Amendments to the Drawings:

The attached sheet of drawing includes the following changes to Fig. 2.

DP-305008

Delphi Technologies, Inc., Troy, MI

FIG. 2

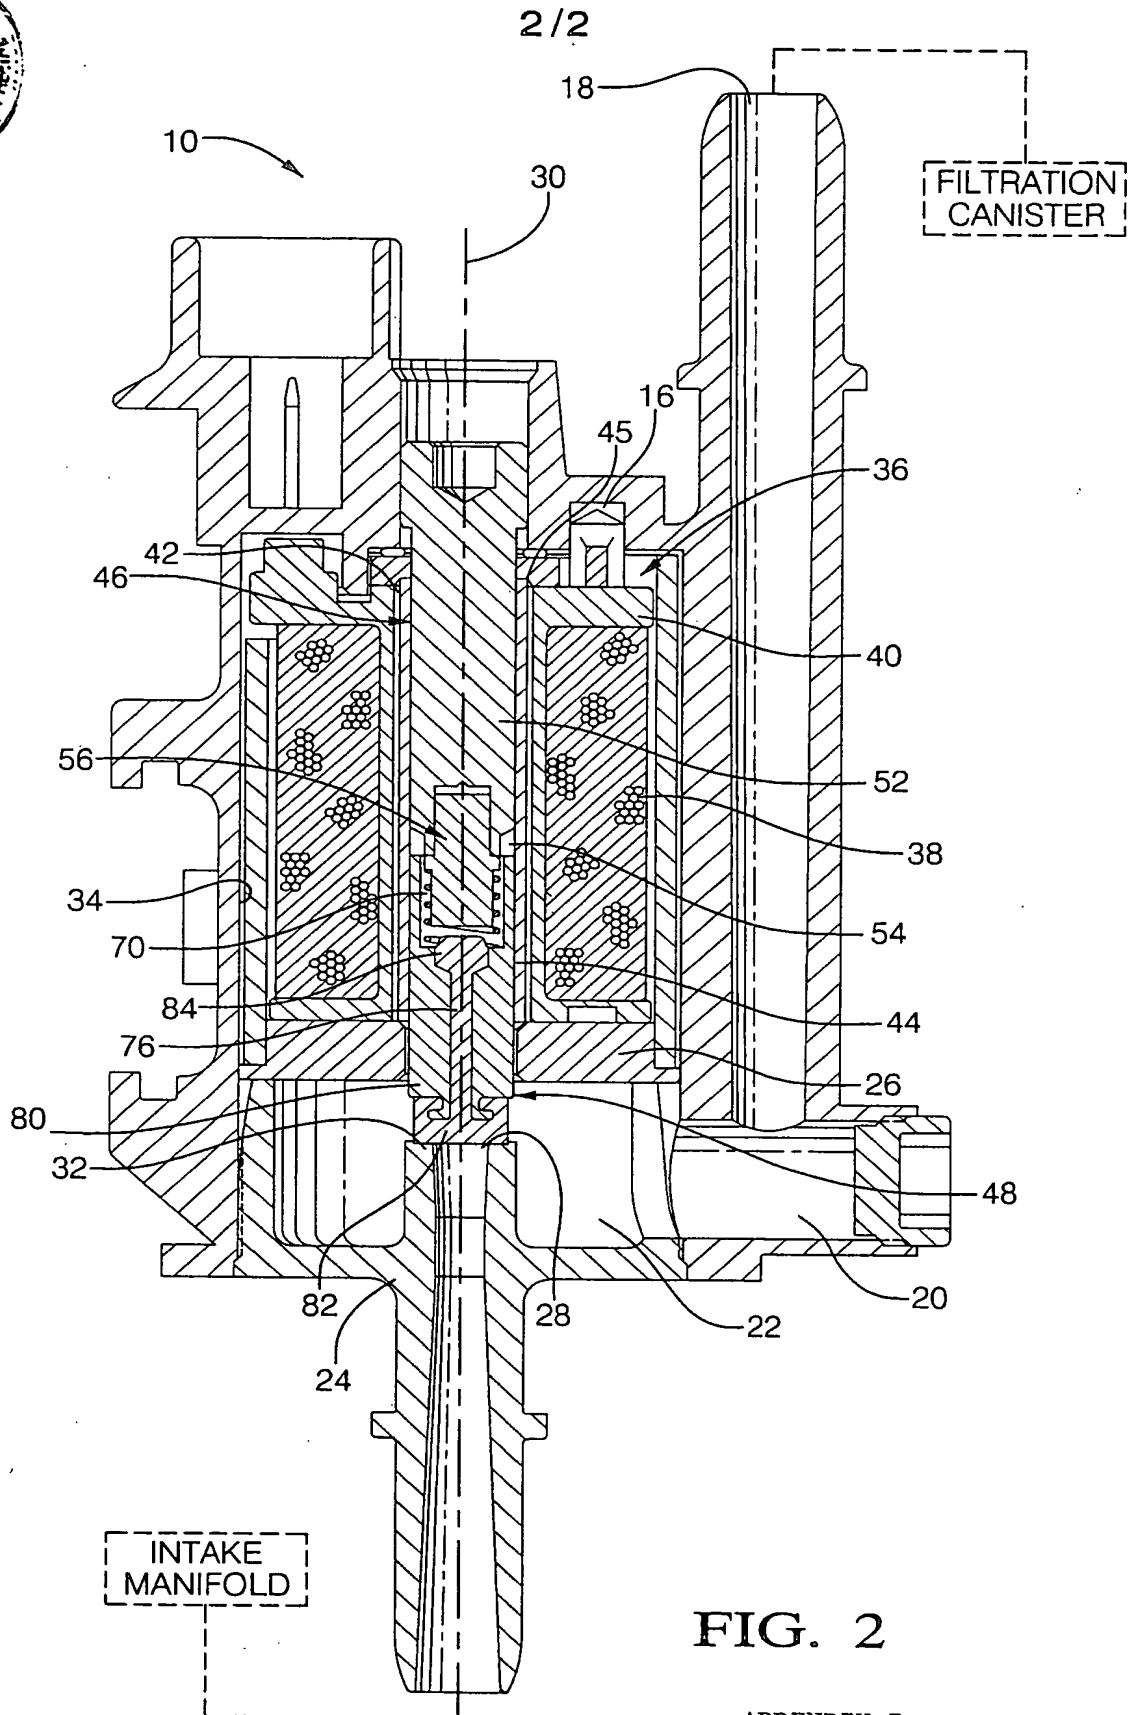
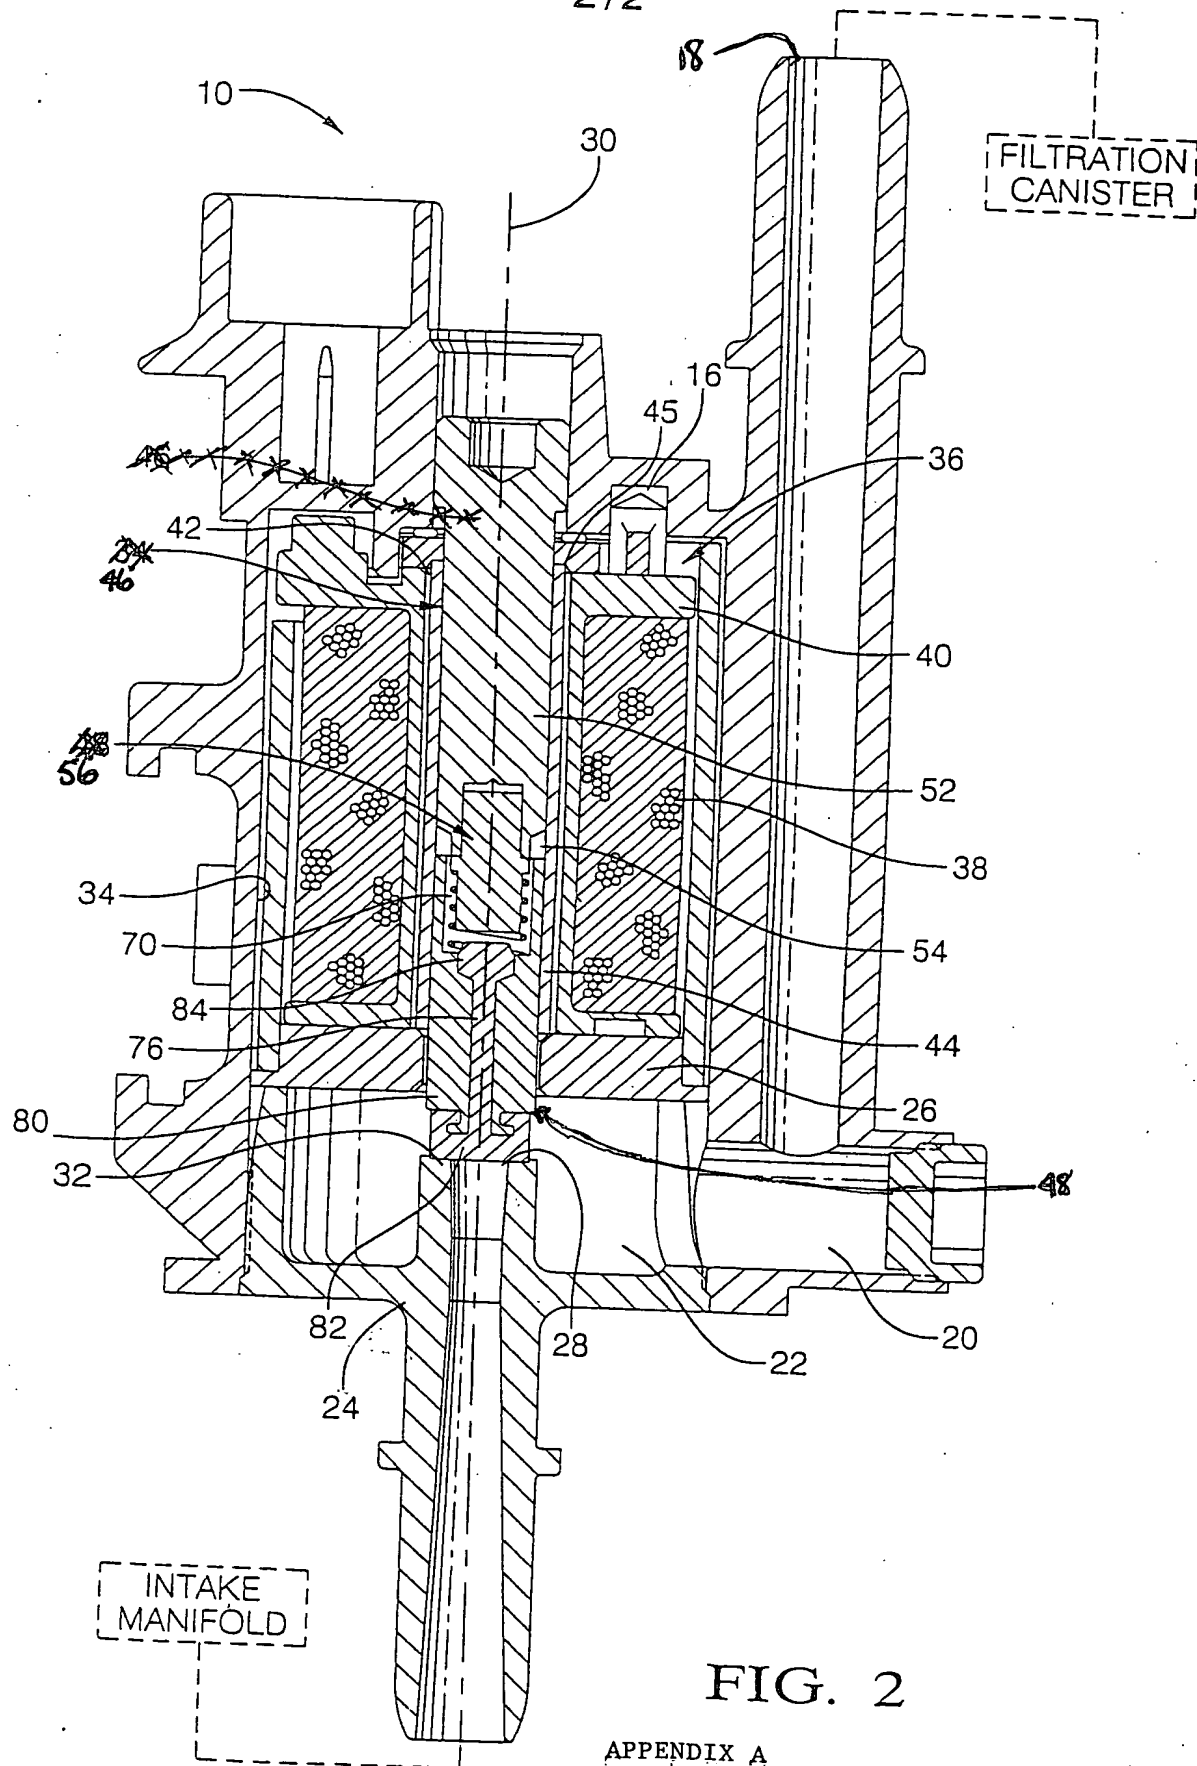
Add Reference No. 18 and leader line directed to the inlet. Further, other corrections have been made to correspond with Figure 3 and the Specification.

Reference No. 48 and leader line is redrawn to be directed towards the plunger. The original Reference No. 48 has now been changed to No. 56 for a non-conductive stop insert.

Reference No. 34 is listed twice in Figure 2. The uppermost Reference No. 34 has been corrected to be Reference No. 46 for the valve stop. The uppermost Reference No. 46 and leader line has been deleted.
